UNITED STATES PATENT AND TRADEMARK OFFICE

APPLICATION NO.	FILING DATE	FIRST NAMED INVENTOR	ATTORNEY DOCKET NO.	CONFIRMATION NO.
10/761,196	01/22/2004	Tian-Yuan Lai	LAIT 3004/EM	2339
23364	7590	10/19/2005	EXAMINER	
BACON & THOMAS, PLLC 625 SLATERS LANE FOURTH FLOOR ALEXANDRIA, VA 22314			CHANDRAN, BIJU INDIRA	
			ART UNIT	PAPER NUMBER
			2835

Office Action Summary	Application No. 10/761,196	Applicant(s) LAI, TIAN-YUAN	
	Examiner Biju Chandran	Art Unit 2835

DETAILED ACTION

FIG. 3

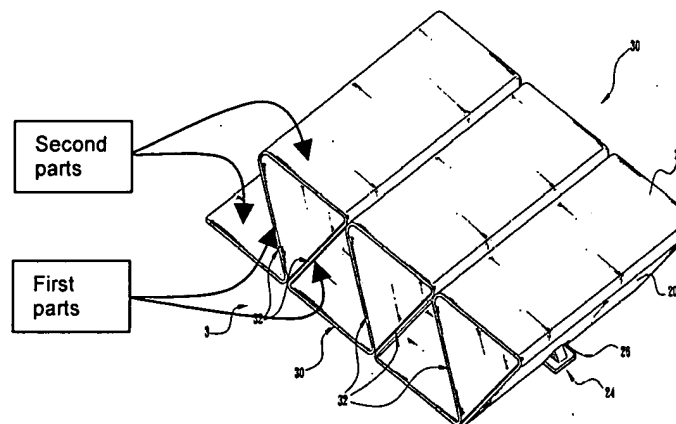
2. Claim 1 rejected under 35 U.S.C. 112, second paragraph, as being indefinite for failing to particularly point out and distinctly claim the subject matter which applicant regards as the invention. Applicant claims

"....wherein any one of said second part is disposed between any two of

said first parts,...". As the attached figure illustrates (applicant's figure 3), this is not met in the applicant's invention.
